ND-17-1495
10 CFR 50.90

Southern Nuclear Operating Company
Vogtle Electric Generating Plant Units 3 and 4
Request for License Amendment Regarding Effect of Rod Shadowing on Excore Power Range
Detectors, Changes to Nuclear Overpower Reactor Trips, and Changes to Monitoring of
Moderator Temperature Coefficient and Core Power Distribution (LAR-17-031)

Vogtle Electric Generating Plant (VEGP) Units 3 and 4

Figure 15.4.2-7
Nuclear Power Transient for an
Uncontrolled RCCA Bank Withdrawal from Full Power
With Maximum Reactivity Feedback (34 pcm/s)

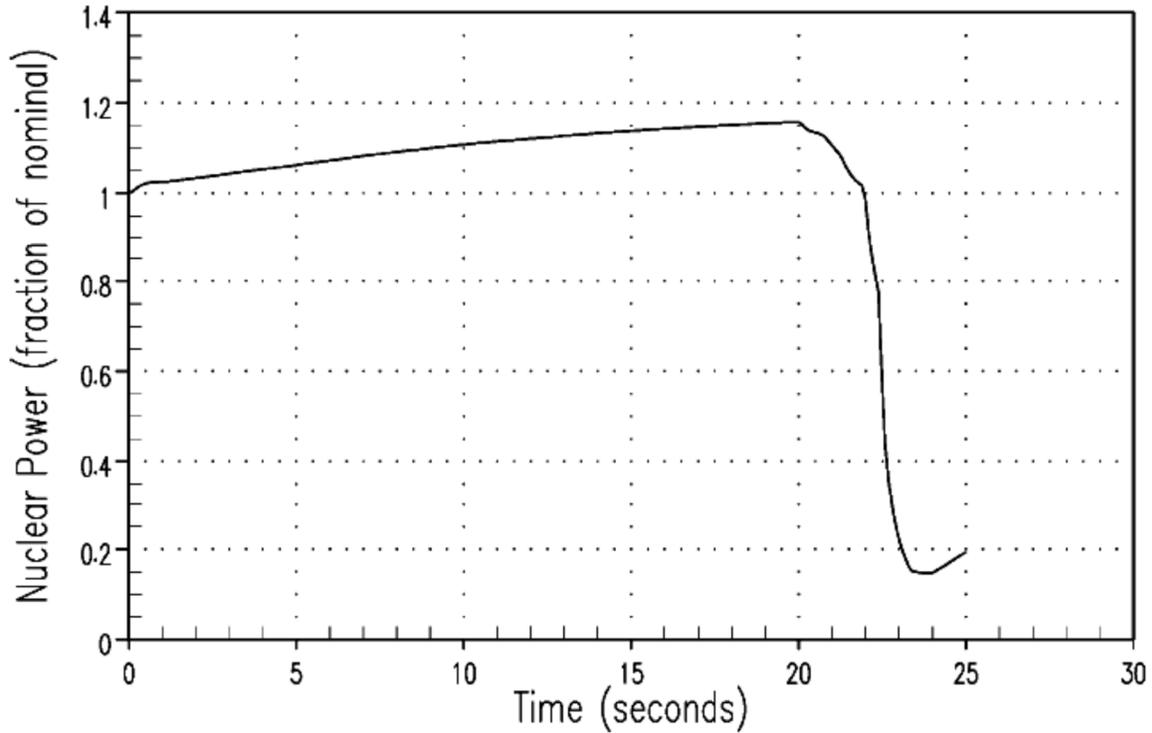
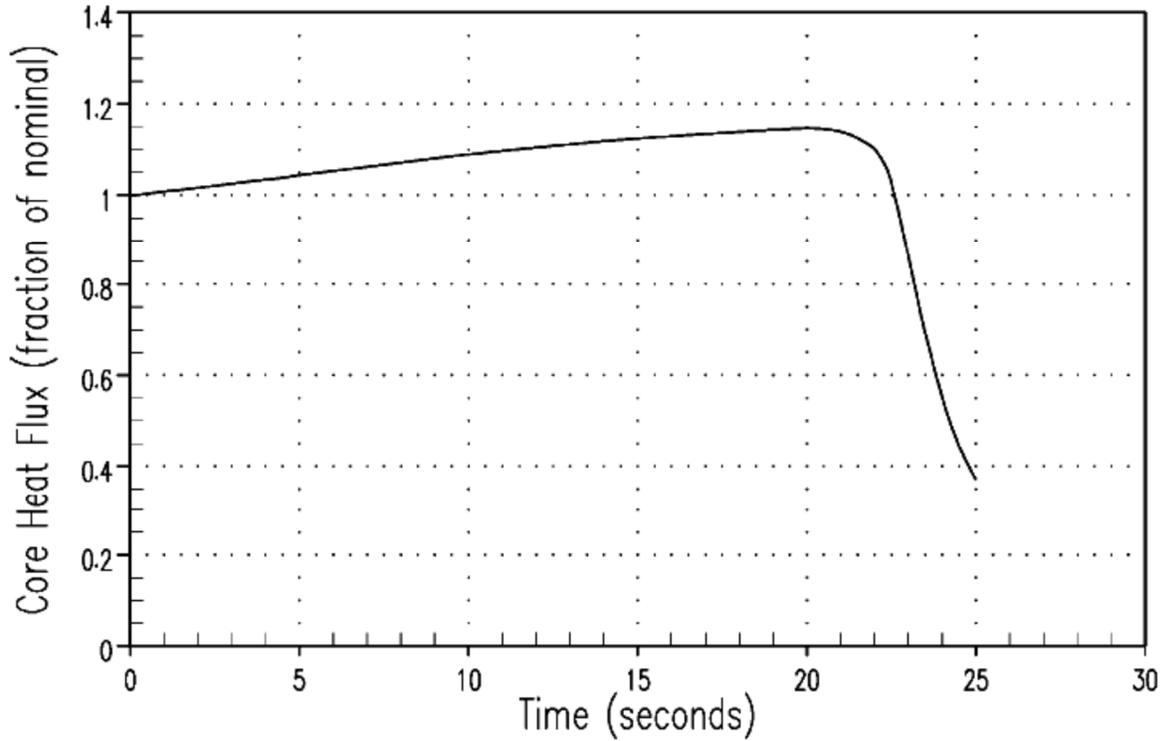
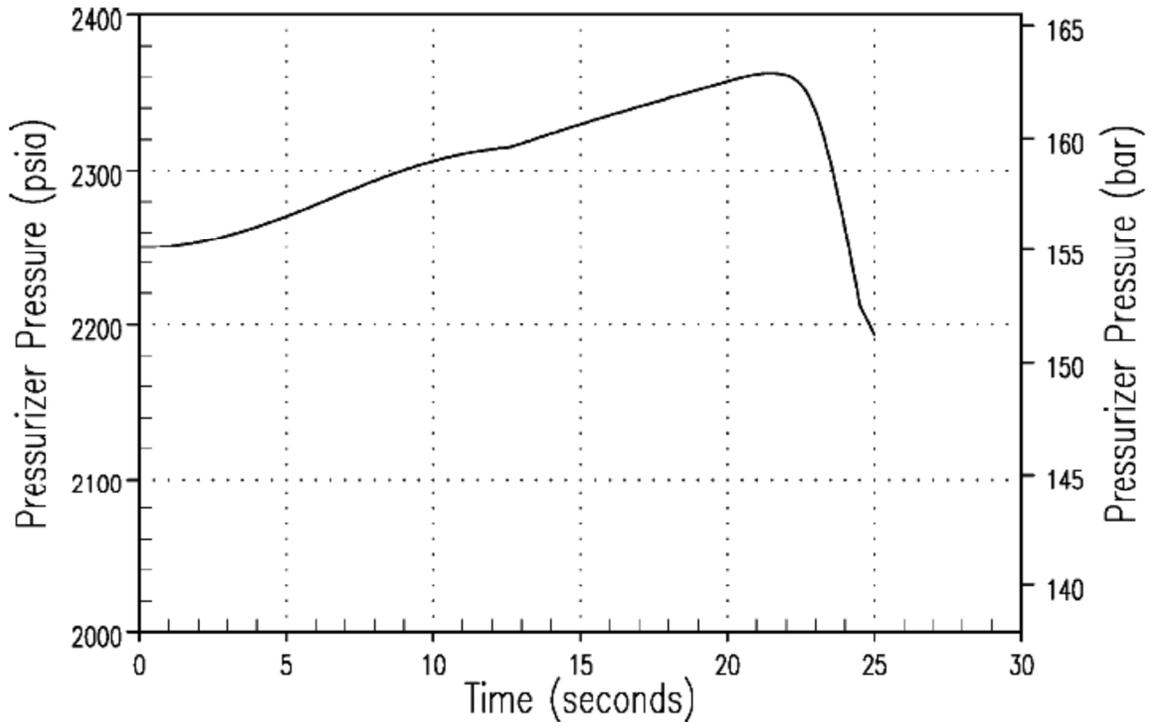
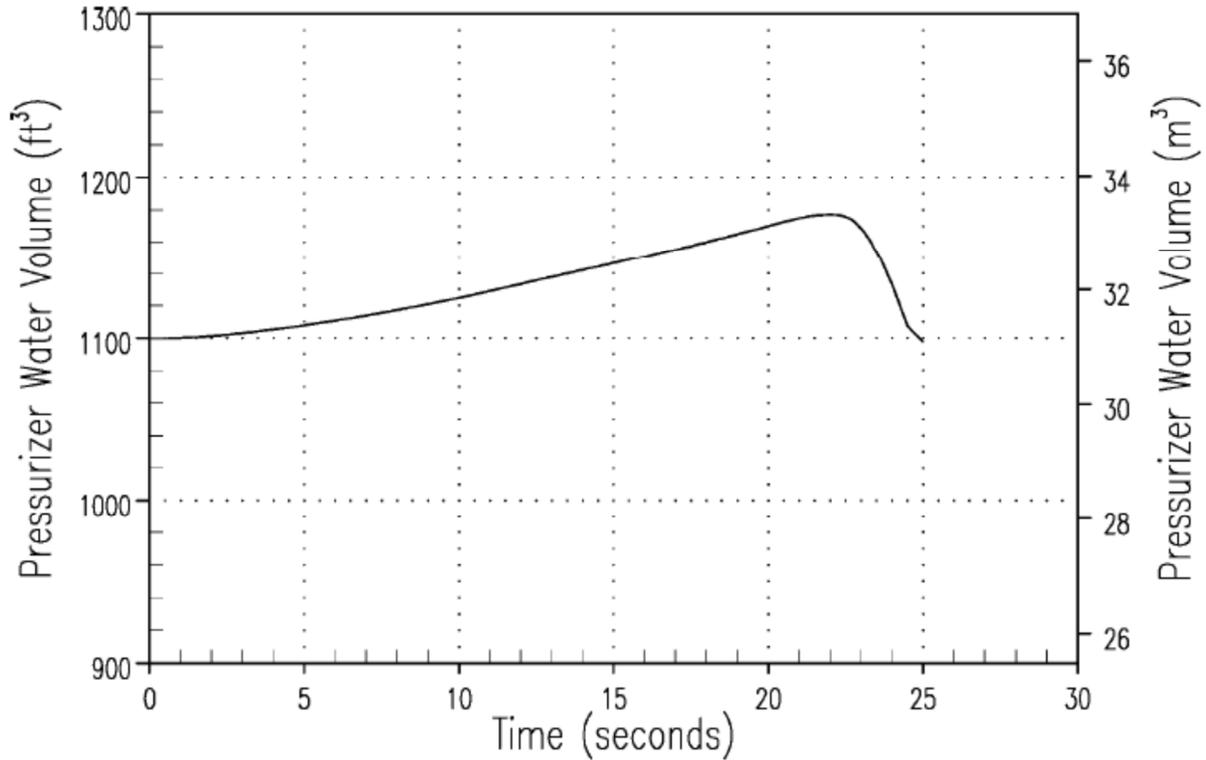
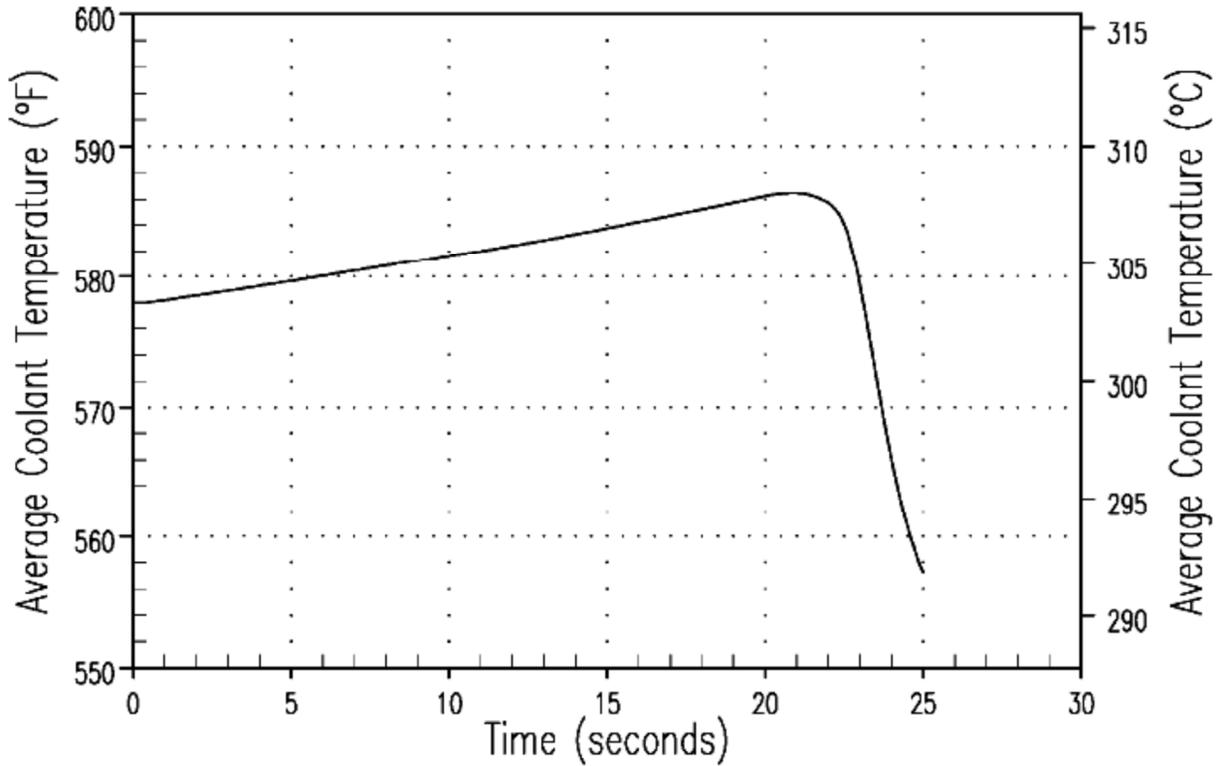
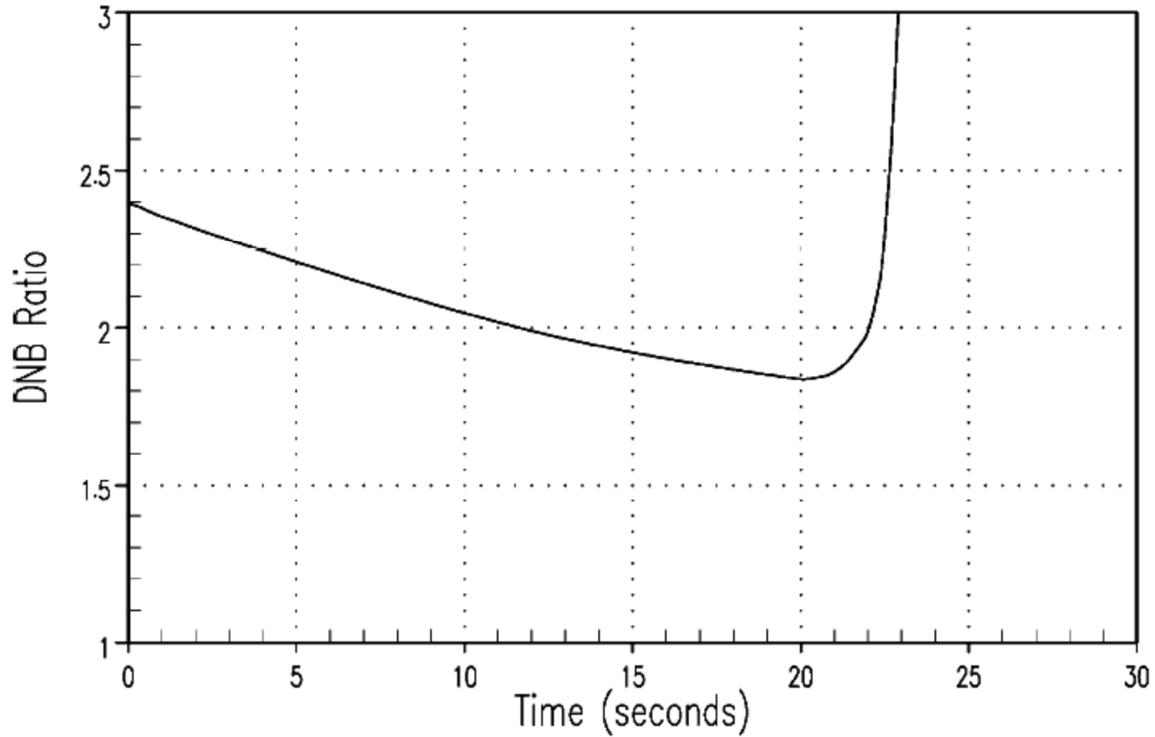
20. New UFSAR Figures 15.4.2-7 through 15.4.2-12 for Uncontrolled RCCA Bank Withdrawal from Full Power With Maximum Reactivity Feedback (34 pcm/s) (corresponding to the new Uncontrolled RCCA bank withdrawal at power accident, Item 2 Case B, in UFSAR Table 15.4-1) are added to reflect the latest analysis results.

The transient response for a representative intermediate (34 pcm/s) RCCA withdrawal from full power is shown in Figures 15.4.2-7 through 15.4.2-12. Reactor trip on overpower ΔT occurs preventing the peak heat flux from exceeding 118%. The DNB design basis described in Section 4.4 is met.

Figure 15.4.2-713
Nuclear Power Transient for an
Uncontrolled RCCA Bank Withdrawal from Full Power
With Maximum Reactivity Feedback (5 pcm/s)

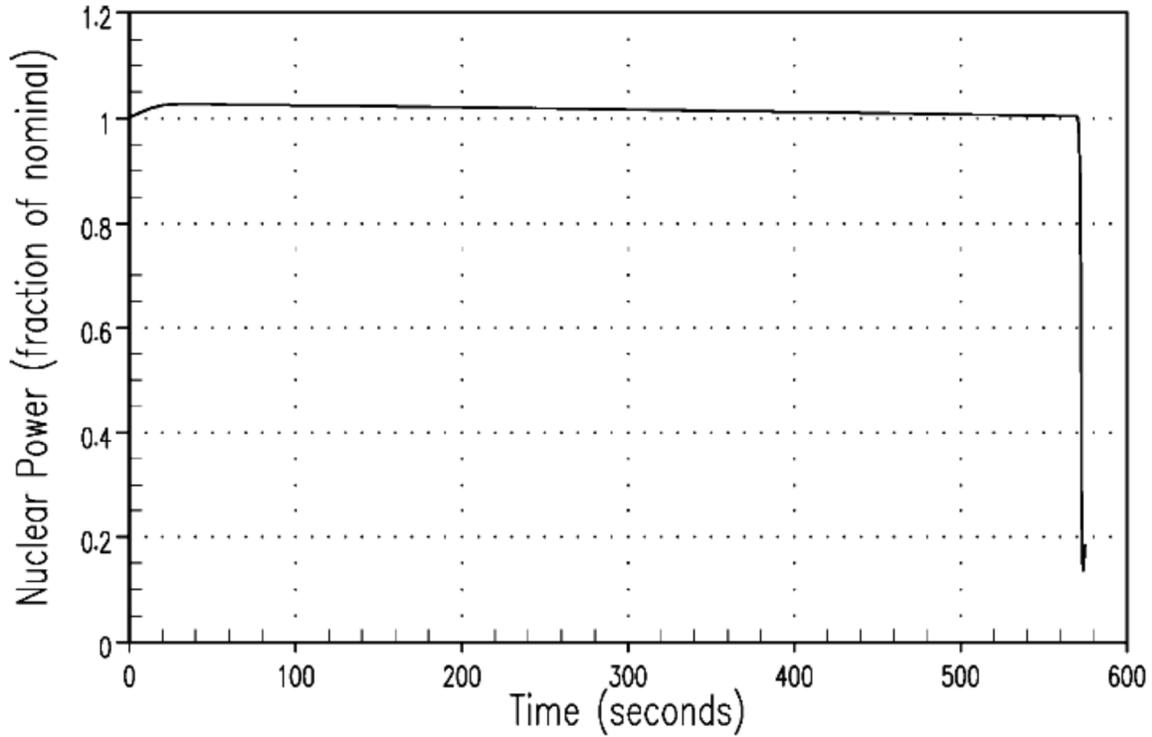
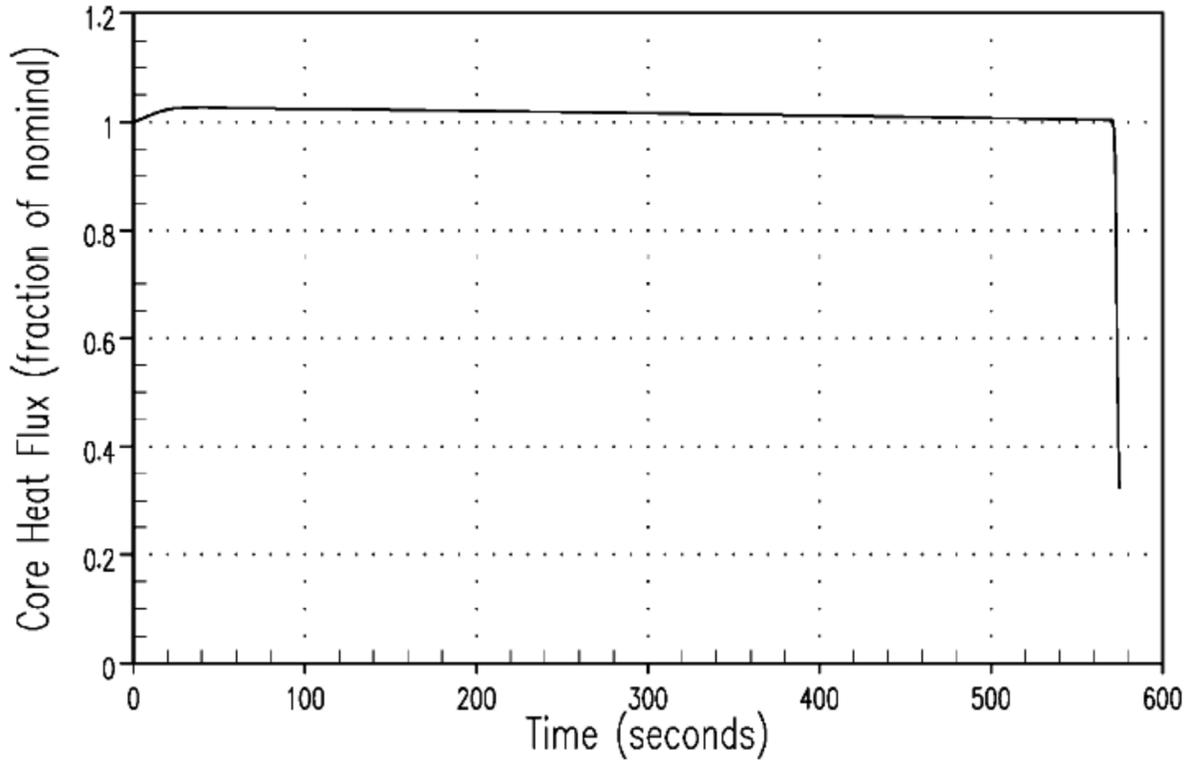
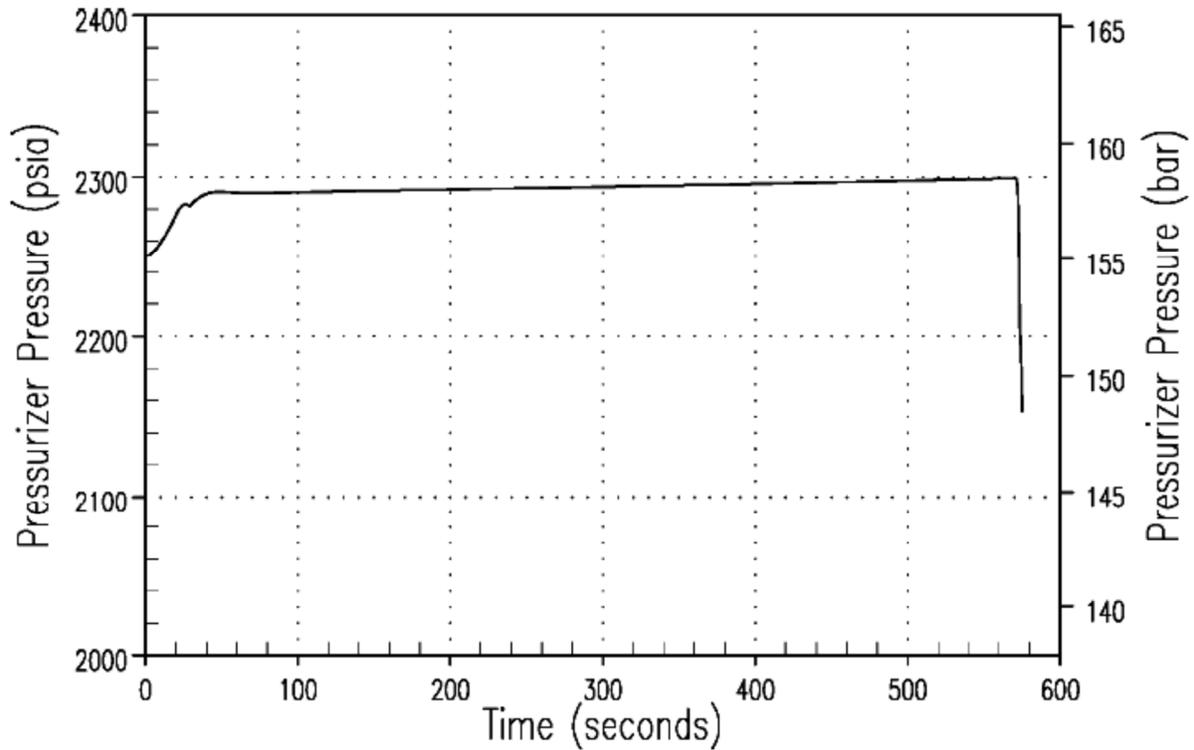
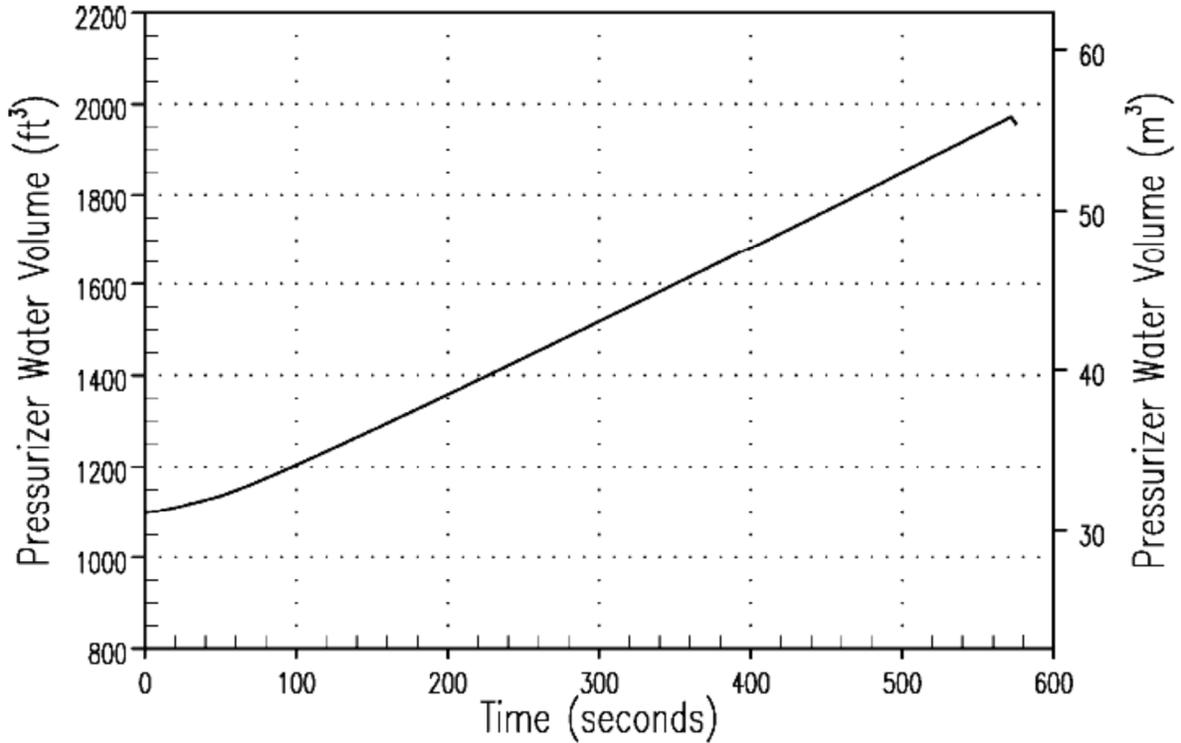
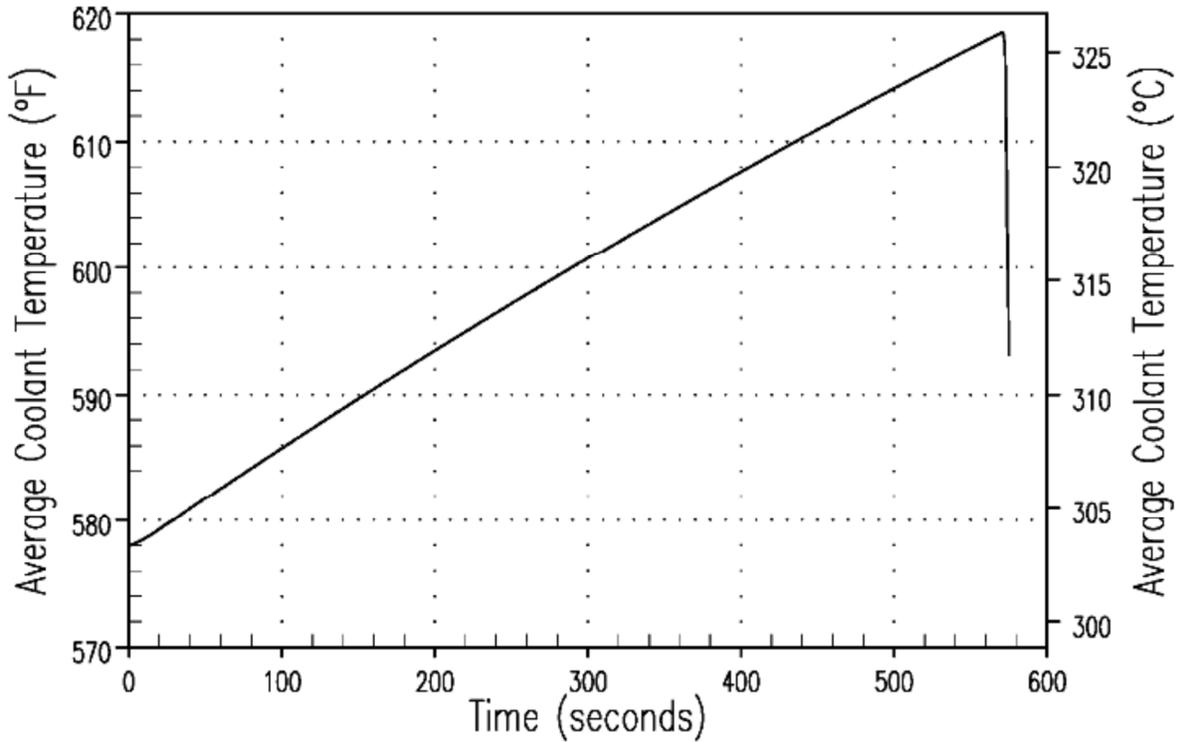
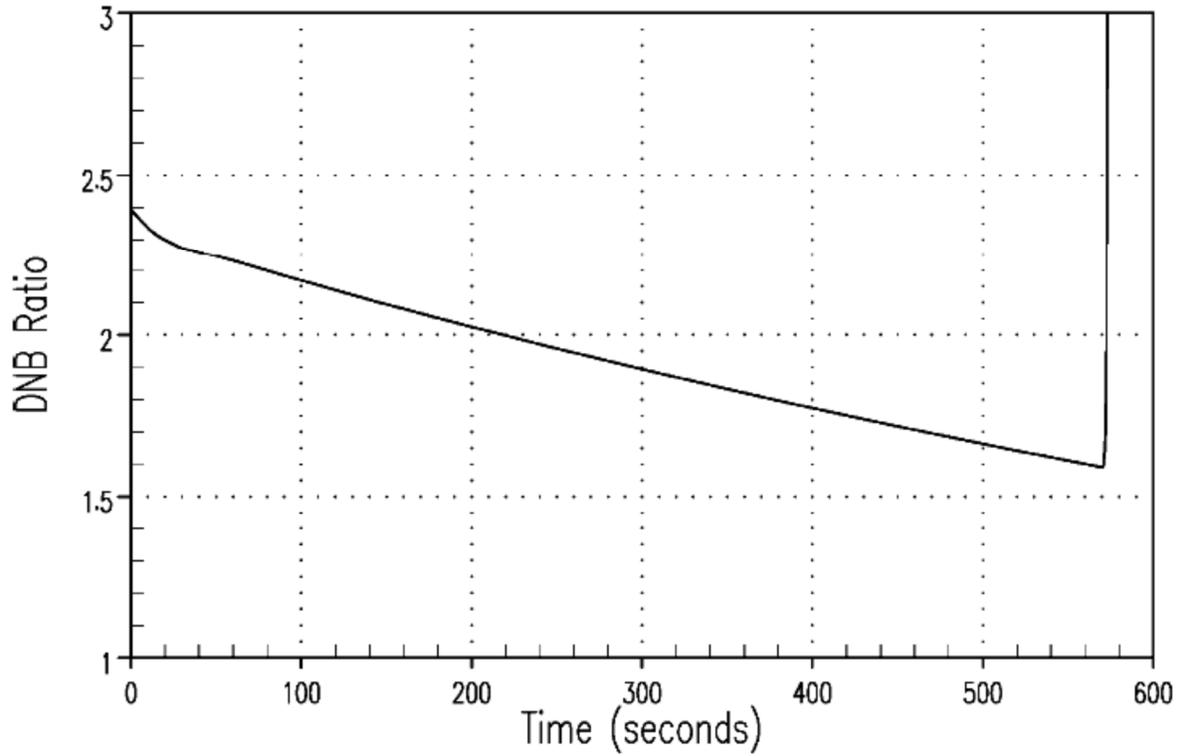
- d. The existing second paragraph becomes the new fourth paragraph, and the references to "Figures 15.4.2-7 through 15.4.2-12" are revised to "Figures 15.4.2-13 through 15.4.2-18."

The transient response for a representative slow (5 pcm/s) RCCA withdrawal from full power is shown in ~~Figures 15.4.2-7~~15.4.2-13 through ~~15.4.2-12~~15.4.2-18. Reactor trip on overtemperature ΔT occurs after a longer period. The rise in temperature and pressure is consequently larger than for rapid RCCA withdrawal. The DNB design basis described in Section 4.4 is met.
